Re: Indian Point Unit 3
Docket No. 50-286
NL-05-010

Subject: Reply to RAI regarding Indian Point Unit 3 Relaxation Requests for Inspection of Reactor Pressure Vessel Head per NRC First Revised Order, EA-03-009 (TAC No. MB3195)

**REPLY TO NRC REQUEST FOR ADDITIONAL INFORMATION
REGARDING RELAXATION REQUESTS FOR INSPECTION
OF IP3 REACTOR PRESSURE VESSEL HEAD**

FIGURE 1
IP3 - PENETRATION NOZZLES
NOS. 74 THROUGH 78 (TYP.)

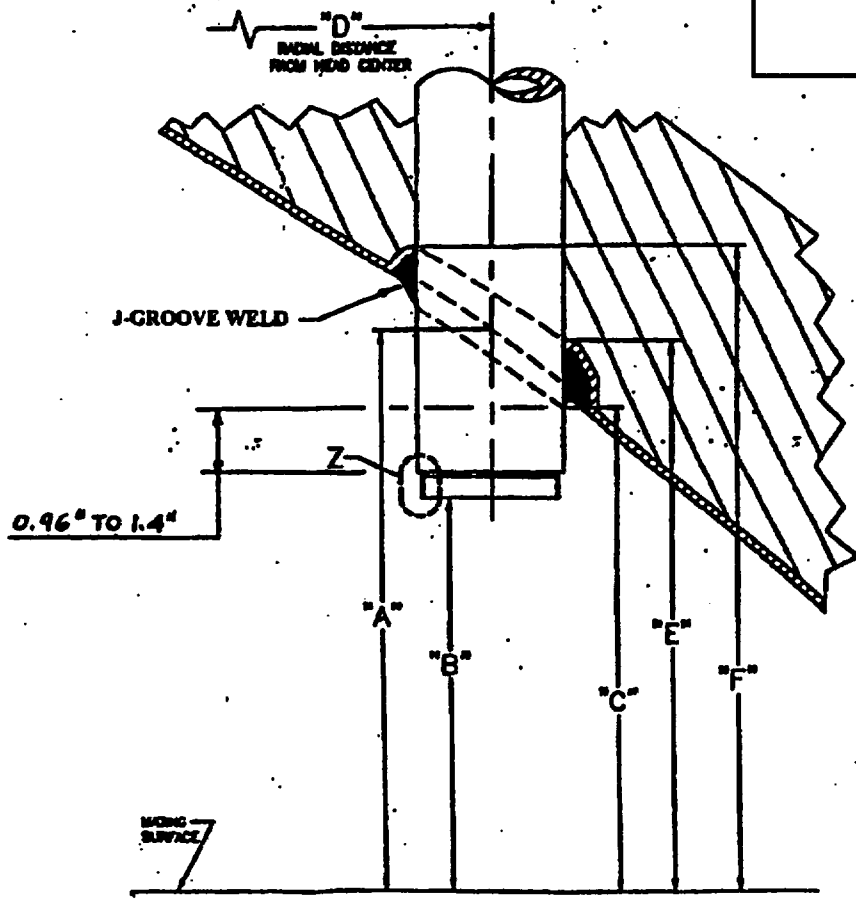
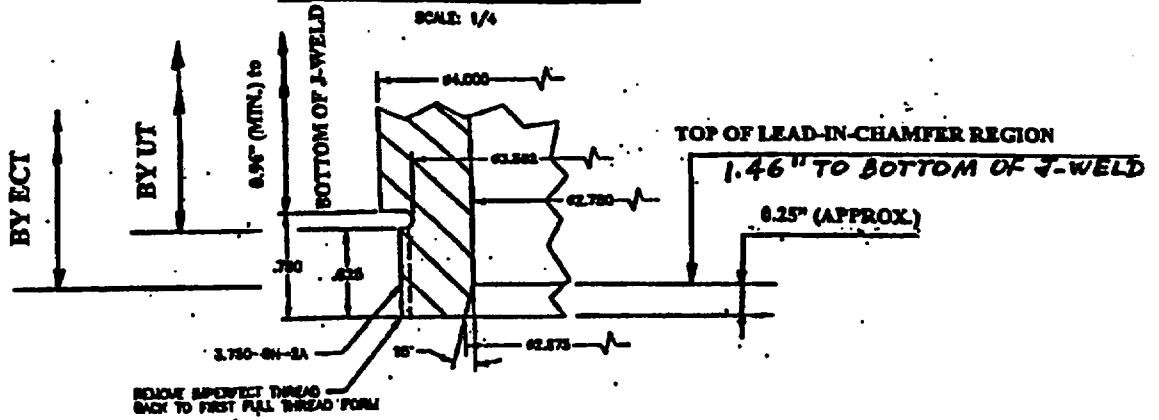
Provide a summary of the crack growth calculation describing the methodology used, including the input assumptions and results. Discuss whether the crack growth rates assessed were based on the equations in MRP-55 and whether the crack growth evaluation was based on the as-built weld geometry.

The First Revised Order allows either ultrasonic testing (UT) examination or a surface examination (i.e. liquid penetrant or eddy current) to be performed. Discuss why a surface examination is not being considered for the threaded area of the five penetration nozzles identified. A surface examination would provide meaningful results on the threaded regions. Discuss any hardships that would be imposed by performing the surface examination (dose, safety risks etc.).

A crack growth evaluation was performed using the methods of MRP-55 for crack growth caused by primary water stress corrosion cracking at a head temperature of 592 degrees F. The nozzle is an open-ended tube so that the operating pressure and temperature are essentially the same at both the inside and outside surface of the tube. For purposes of this analysis, a conservatively high hoop stress of 30 ksi was assumed, as compared to the calculated stresses of less than 20 ksi as noted above (Reference 5, First Revised Order EA-03-009, page 10). An initial hypothetical flaw is assumed to exist with a worst-case orientation (axial) and flaw growth occurs in a single direction toward the J-groove weld. Because the location of the hypothetical flaw is in the threaded region, at least 0.96 inches from the J-groove weld, the weld residual stresses are also negligible. The evaluation confirmed that the hypothetical flaw would not grow to the J-groove weld over at least 4 years of operation. The weld geometry dimensions are taken from the IP3 plant specific drawing (IP3V-0439-1680) entitled: "Indian Point Unit 3, RVH Penetration Inspection, Interface Dimensions". Refer to the attached Figure 1 for the location of these dimensions on the penetration nozzles.

The inspection methods and results performed during Refueling Outage 3R12 in April 2003 were submitted in Entergy's letter to NRC, NL-03-098, dated June 12, 2003. The non-visual NDE portion of the examination for the referenced five penetration nozzles was performed using a single probe assembly that contained a pair of transducers for the UT examination and an eddy current coil for the ECT surface examination. The axial coverage with this probe assembly extended down to approximately 0.75 inches from the bottom of the nozzle (for the UT exam) and down to approximately 0.25 inches from the bottom of the nozzle (for the ECT surface exam). Meaningful UT data below approximately 0.75 inches was limited by signal dispersion in the threaded region. Meaningful ECT data below approximately 0.25 inches was also limited

because the eddy current coil tends to lose contact with the examination surface as it reaches the lead-in chamfer region (see attached Figure 1). As discussed in the response to Question 3a above, the hardships in removing the guide funnels welded to the bottom of the nozzles precludes examination of the OD wetted surface areas of the nozzle tubes.
